ADDENDUM NO.: 1.0

DATE OF ADDENDUM: October 16, 2014

**Founders Hall Renovations for Allied Health and Nursing
Naugatuck Valley Community College, Waterbury, Connecticut
BI – CTC – 442 – CMR**

SKETCH NO.
AD1-SK-27/A5.8

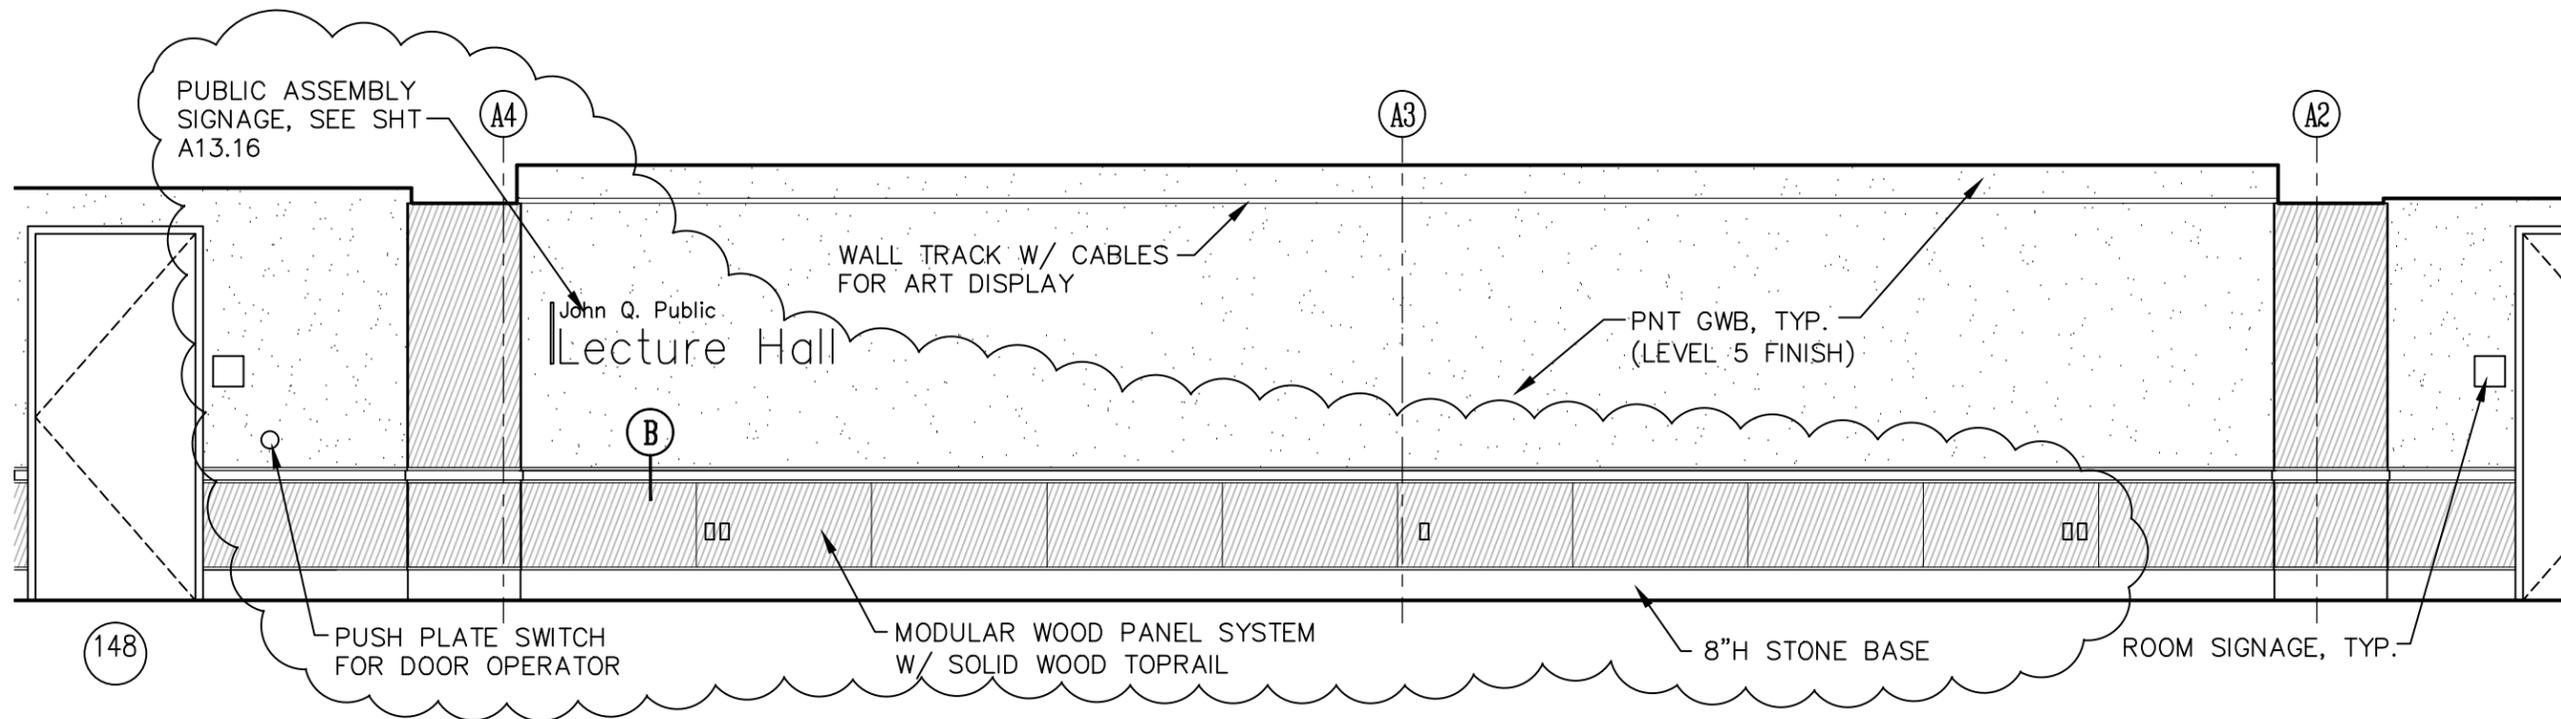
- a. **REVISE** left-hand window horizontal detail "Q" to "U".
- b. **REVISE** (upper) detail 24/A5.8 of head detail to "27/A5.8" per attached sketch AD1-SK-27/A5.8.

DATE 10/15/2014
 COPYRIGHT © Moser Pilon Nelson Architects
 SCALE: AS NOTED
 SKETCH NO. AD1-SK-A8.3

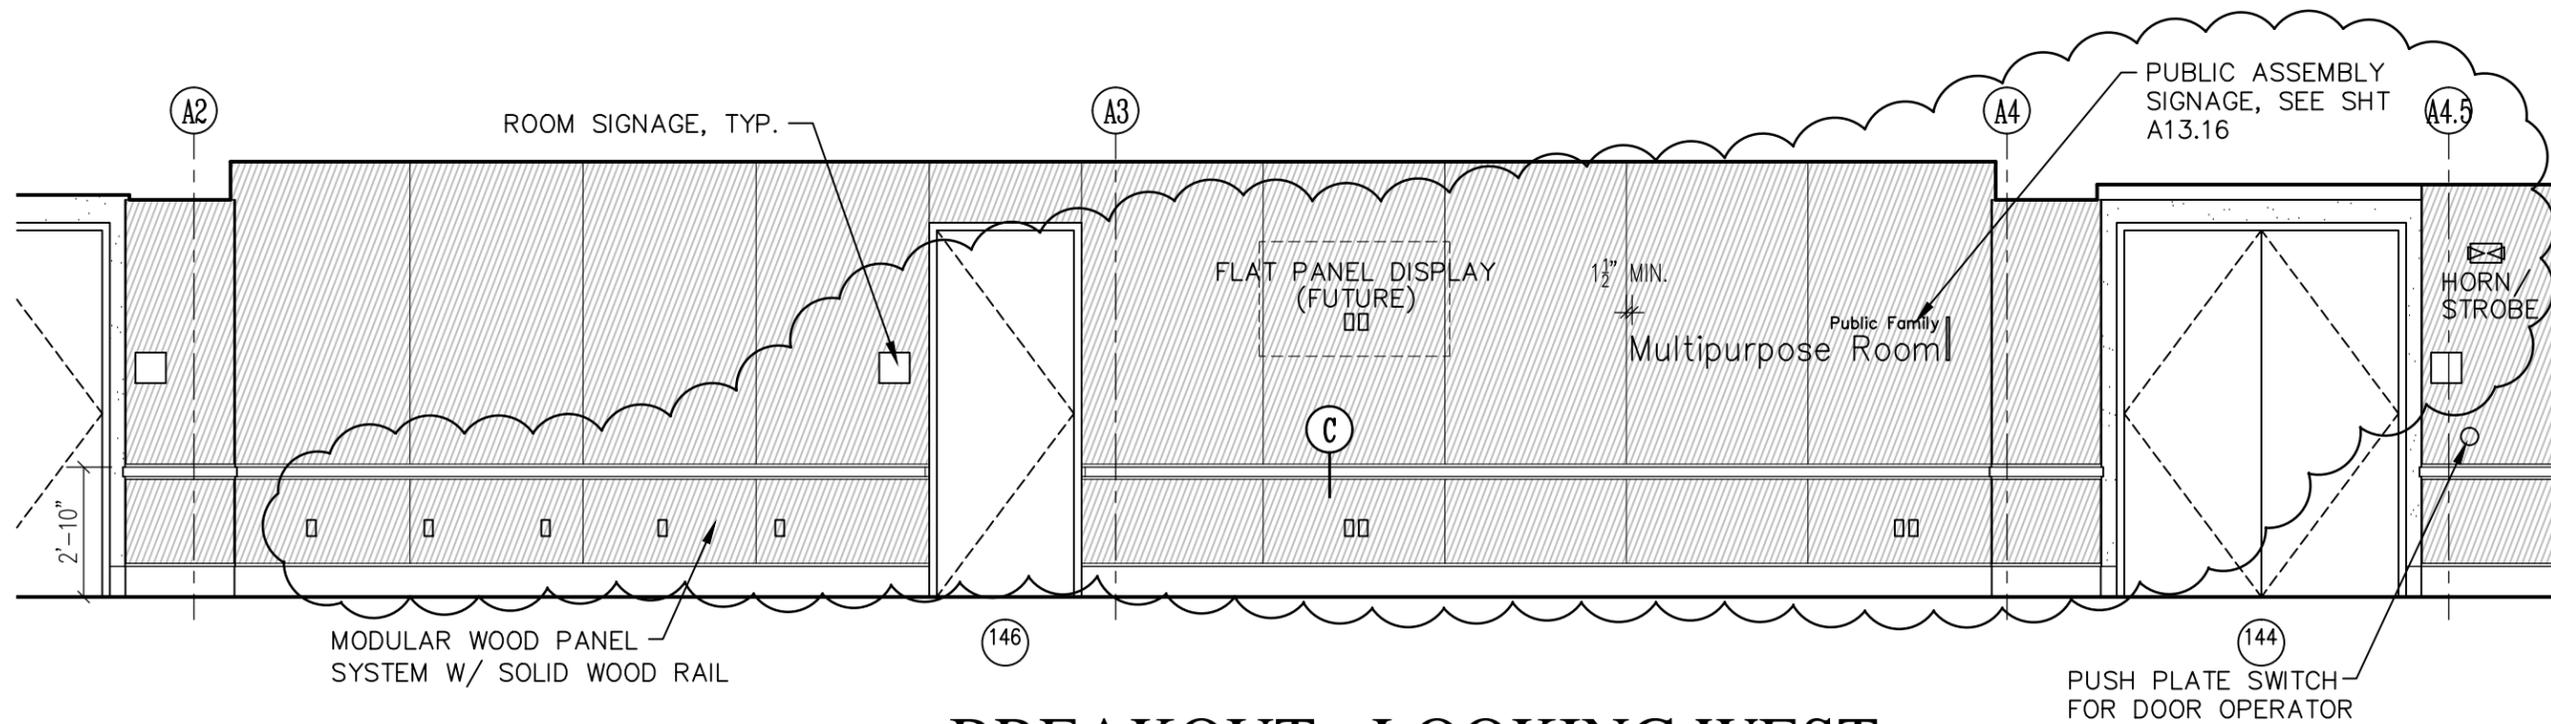
- a. **ADD** general note to read “see A13 drawings for additional signage”.
- b. At elevation 5 **REVISE** location of ADA panel sign from door 134 to perpendicular wall to its right.
- c. **REVISE** elevations 9 and 11 to coordinate with signage on A13 drawings per attached sketch AD1-SK-A8.3.
- d. At elevation 12, between display case and column line EX2 **ADD** three rectangles and related notes to indicate relocated plaque, green sign, and healthy sign (noted as ‘EG’ on A13 drawings).
- e. At elevation 13 **ADD** note and **REVISE** lettering at café soffit to coordinate with signage shown on sheet A13.12.
- f. At elevation 14, to right of column line Ae **ADD** two rectangles and related notes to indicate new bronze plaque and future LEED plaque.

AD1-SKA-11.12-1

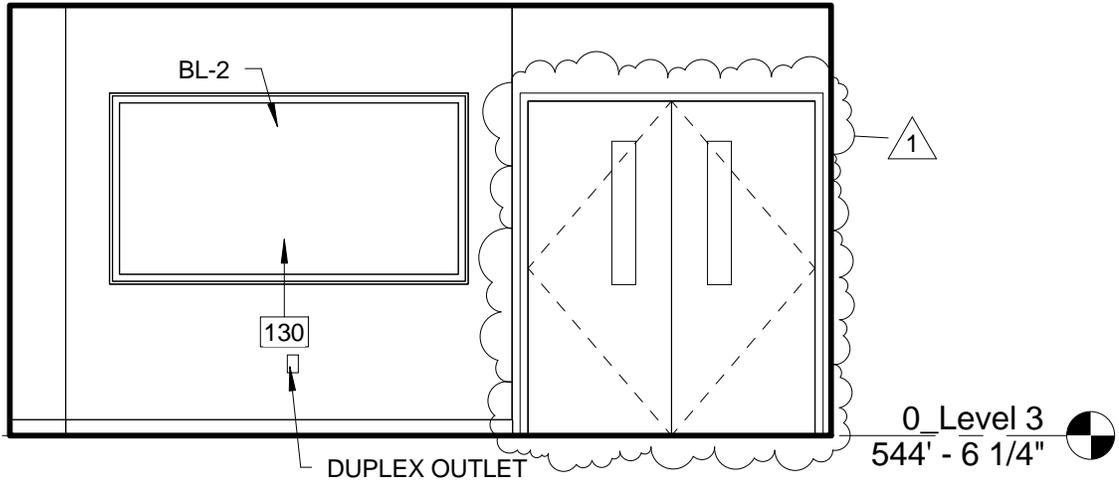
- a. At Keynote Legend **REVISE** #120 to read "magnetic dry-erase board".
- b. At Controls F330 and F333 shown on plan 1, **ADD** two grommets to each counter.
- c. At plan 1 **DELETE** existing columns at 1-K and 1-J that are being removed.
- d. At elevations 9 and 14 **REVISE** door types as shown on attached sketch AD1-SKA-11.12-1.

AD1-SKA-11.16-1

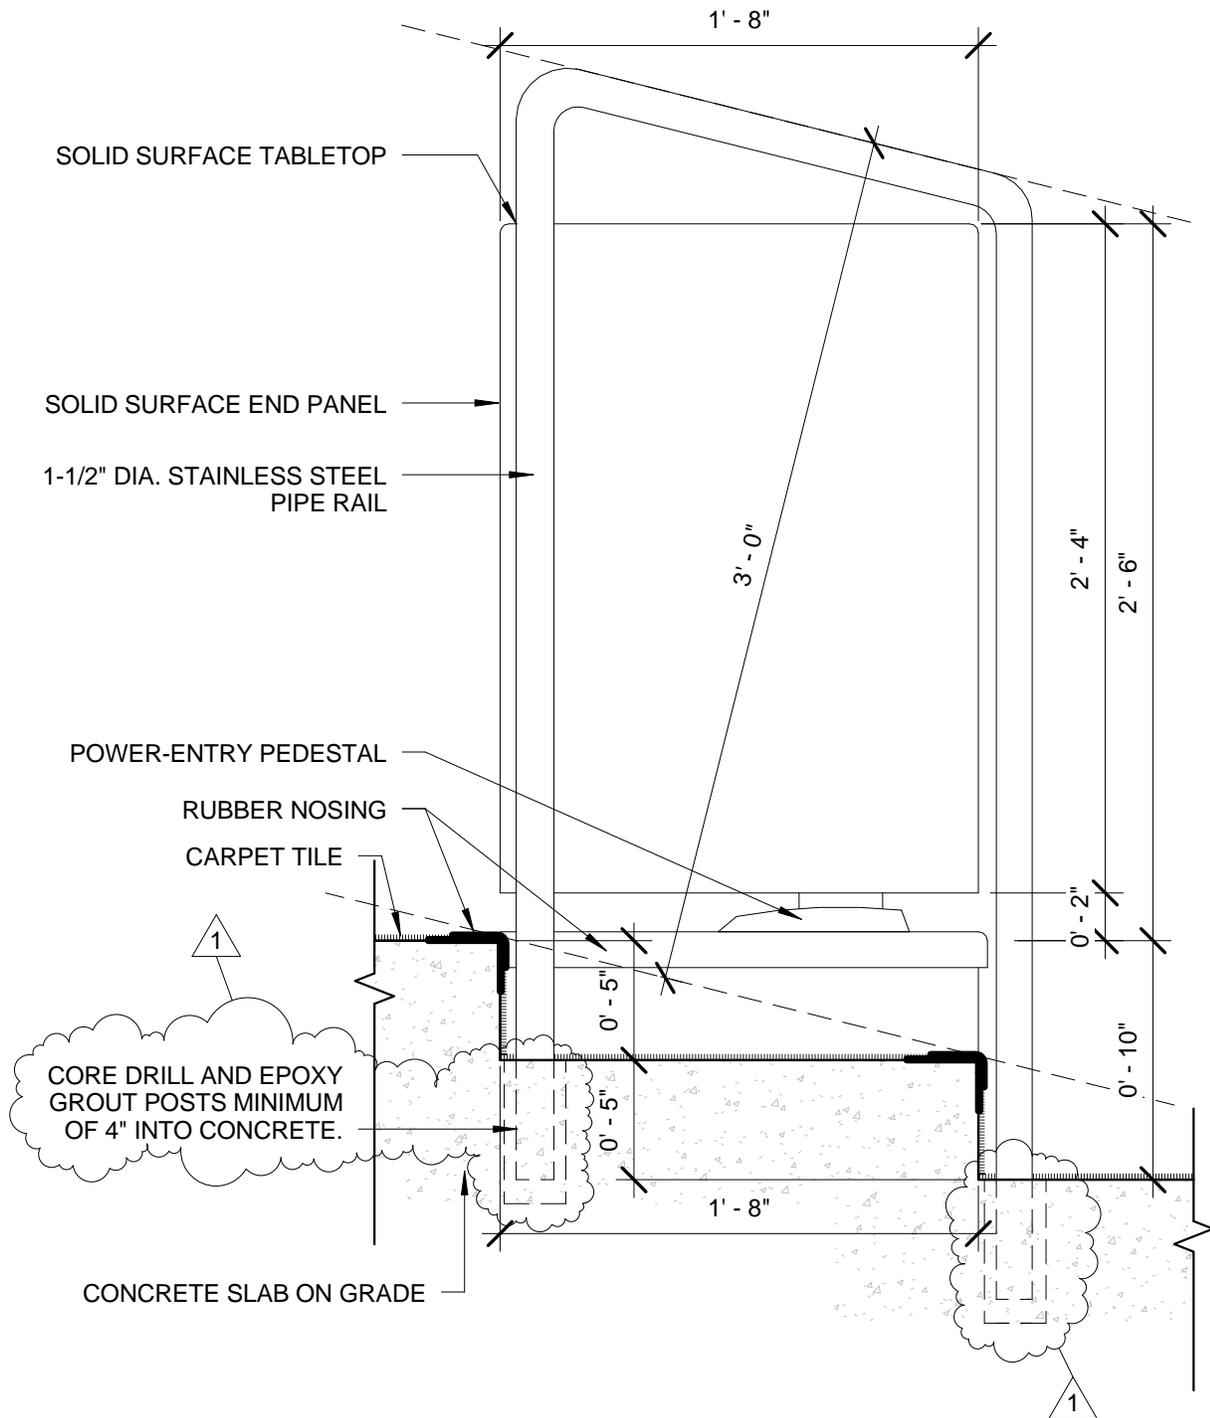
- c. At ambulance simulator shown in plan 1, **ADD** note “provide wood trim piece as required” where simulator abuts gwb wall construction.
- d. At detail 1 **REVISE** location of fixed lecture tables to allow for handicapped accessible clearances as shown on attached sketch AD1-SKA-11.16-1.
